**CITY OF LA PALMA
COMMUNITY SERVICES DEPARTMENT**

ADDENDUM NO. 1

**VARIOUS MEDIAN ISLAND PROJECT
CITY PROJECT NO. ST-371**

MAY 15, 2023

BOULDER INSTALLATION

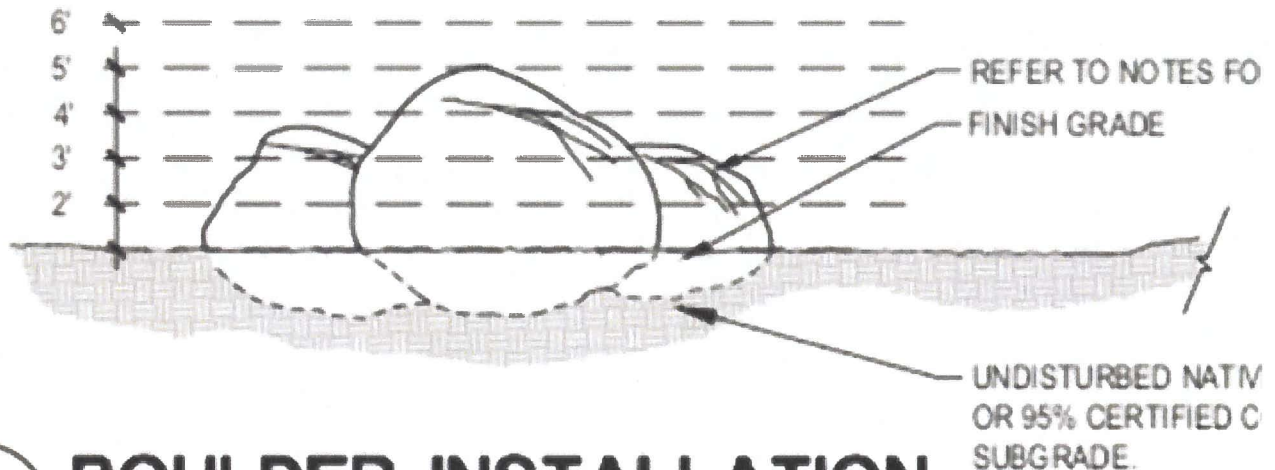
Per the bid schedule it shows a measurement and payment for Boulders. Where on the plans does it have the designation of where the boulders are located? Also the detail on sheet 26 shows the sizes A, B and C but what is the quantity of each size?

Equally distribute the sizes over the bid quantities for each segment.
